Summary	Add Blue loctite to motor mounting bolt on Wyndstar MT			
Products Affected	Wyndstar MT, Carwash			
Key Word Tags	Wyndstar MT, MT, Motor, Bolt			
Tools/Equipment (If Required)	Wrench, Loctite blue 242			
Parts/Materials (If Required)				
Related Media				
Author	Randy Meyer	Issue Date	4-10-13	Status Active

Figure 1

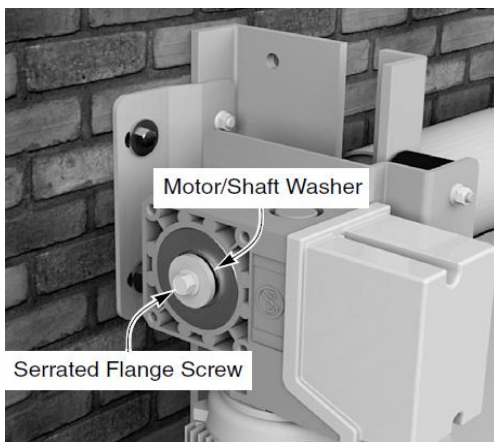
The Wyndstar MT carwash model door has experienced some motor bolts loosening after installation. See figure 1.
